Product Change Notification

Change Notification #: 115223 - 00
Change Title: Intel® Server System R2224WTTYSR,
PCN 115223-00, Product Design,
Bracket update and cover screw removal
Date of Publication: January 05, 2017

Figure 1. PCIe* Riser Bracket

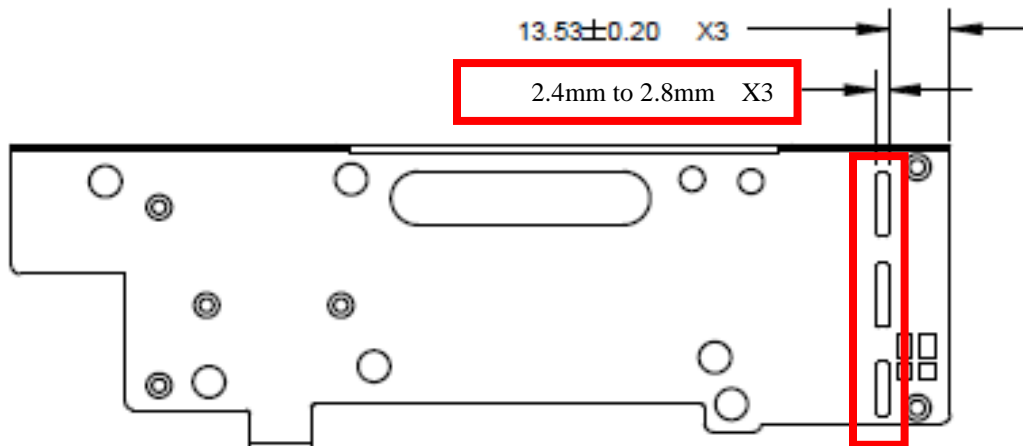
1. The width of the holes in the PCIe* Riser bracket will change from 2.4mm to 2.8mm.

Figure 2. Remove the screw from the top cover

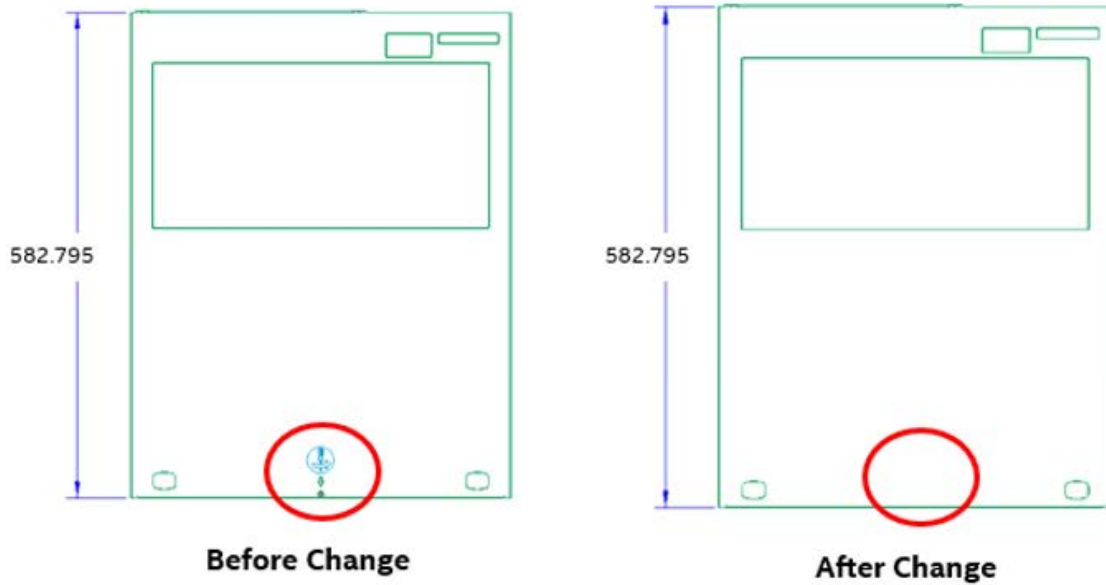
- Screw from the Top Cover will be removed to provide tool-less assembly.
